# Ventura County Community College District

DATE: 06/14/2024  
TO: All Bidders  
FROM: David Cienfuegos, Purchasing Specialist  
SUBJECT: Addendum 1 – Bid 676 Moorpark College Parking Lot Repair

# Lot 21 Utility Survey

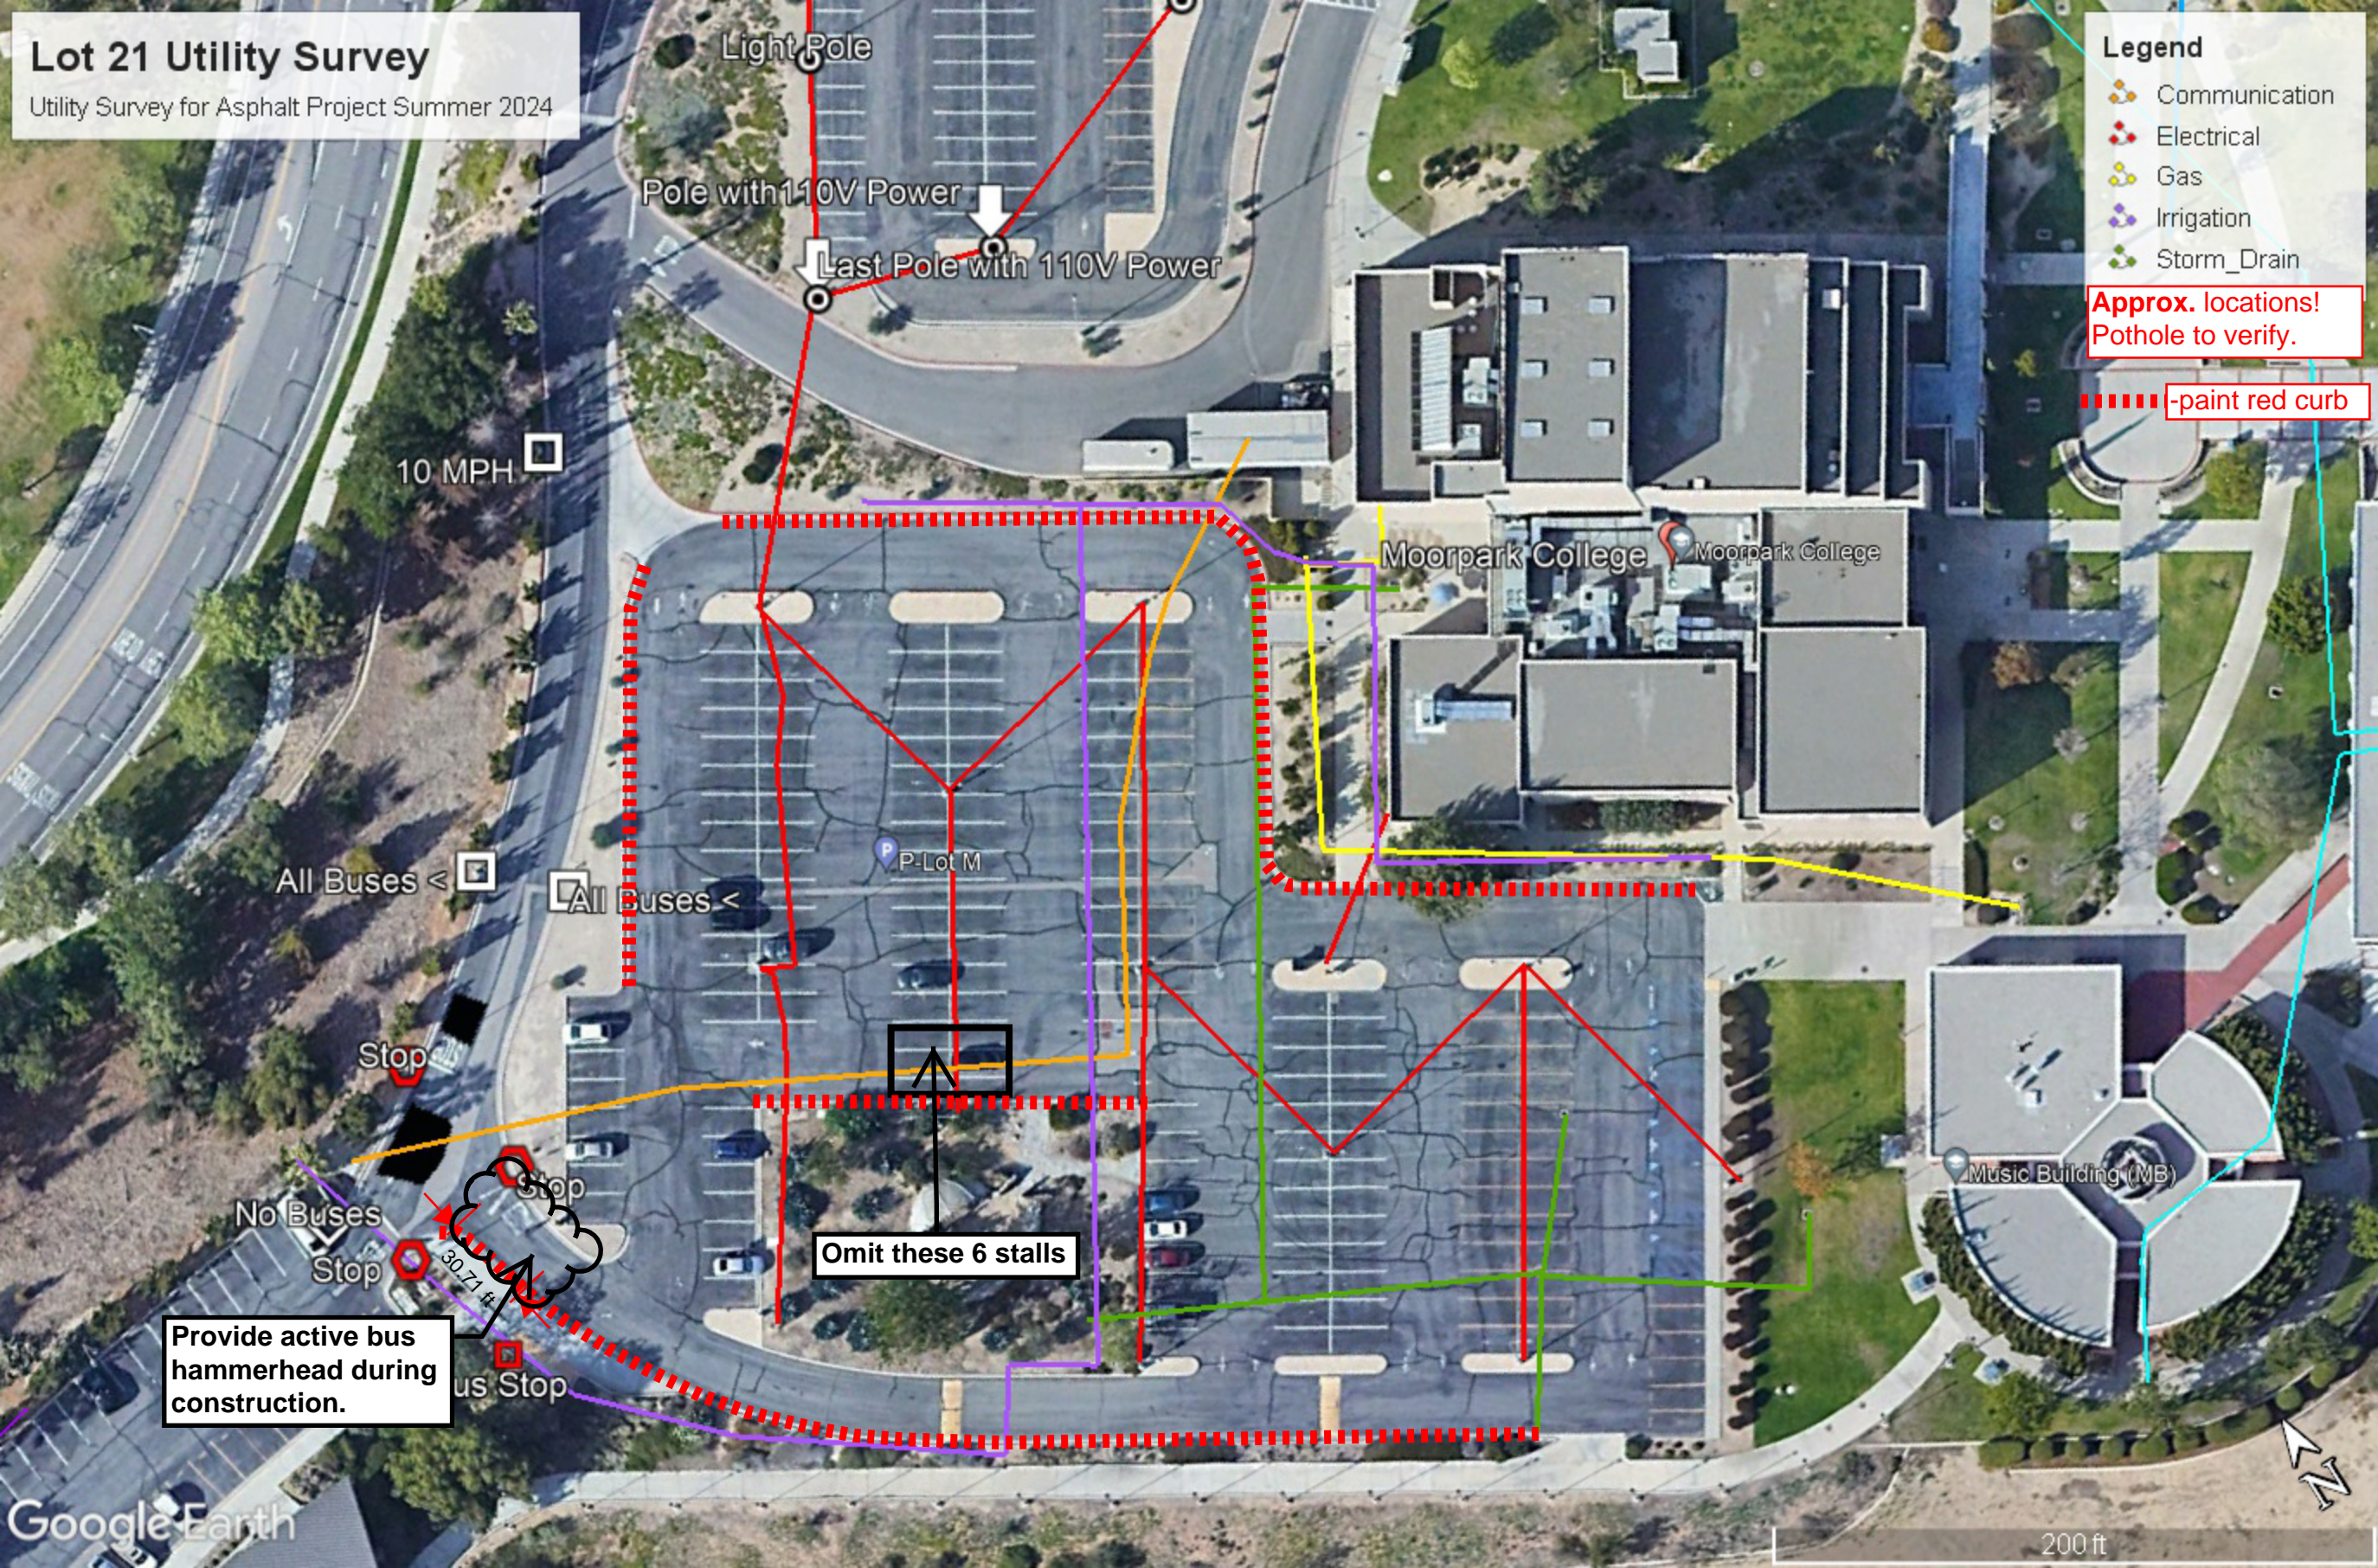
9. Are the utilities marked?
  - a. Shallow utilities have been marked however the contractor must pothole. See Exhibit A.

10. Will striping be provided to the contractor?
  - a. Contractor will need to memorialize the lot striping and keep to it when restriping the lot. Refer to Exhibit A for the elimination of 6 stalls.

**Approx. locations!**  
Pothole to verify.

Omit these 6 stalls

Provide active bus hammerhead during construction.
